From: Gilbert M Whitson
Sent: Tuesday, August 23, 2011 4:12 PM
To: 'Steve Gould'; 'jalvarez@fnal.gov'
Subject: FW: reminders

-----Original Message-----
From: Fred Nobrega [mailto:nobrega@fnal.gov]
Sent: Tuesday, August 23, 2011 2:31 PM
To: Gilbert M Whitson
Subject: reminders

MBH02

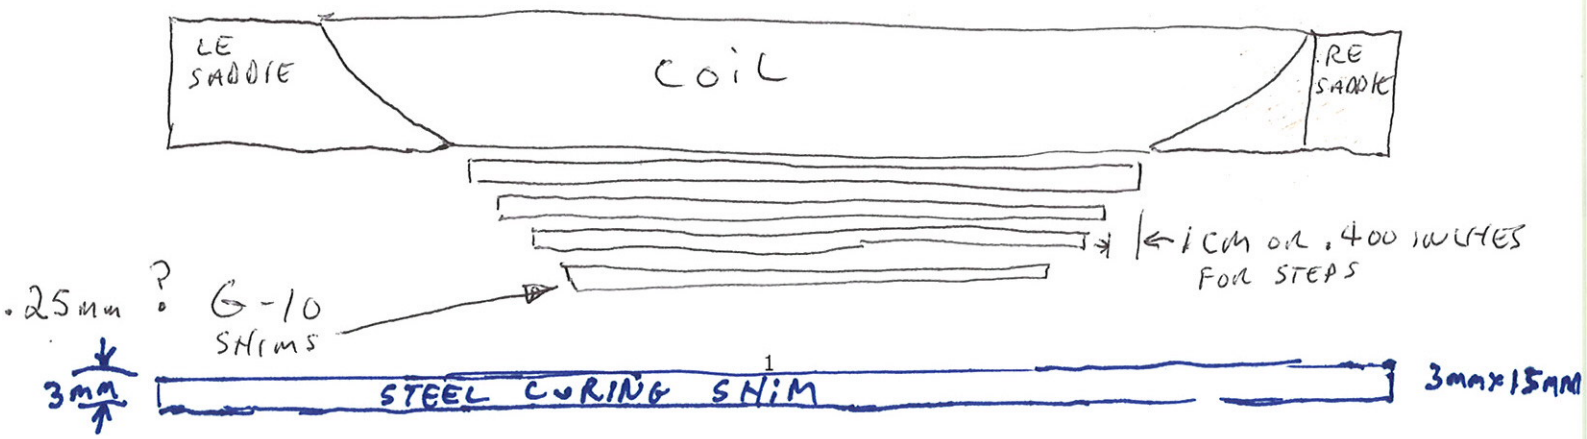
2) make a 0.5mm (~20mil) G-10 curing shim for 11-Tesla Dipole L1 & L2 between the saddles.

MAY INCREASE SHIM THICKNESS TO 1mm TOTAL. FIND OUT FOR CERTAIN FROM RODGER BOSSERT BEFORE PACKAGING L1 FOR CURING.
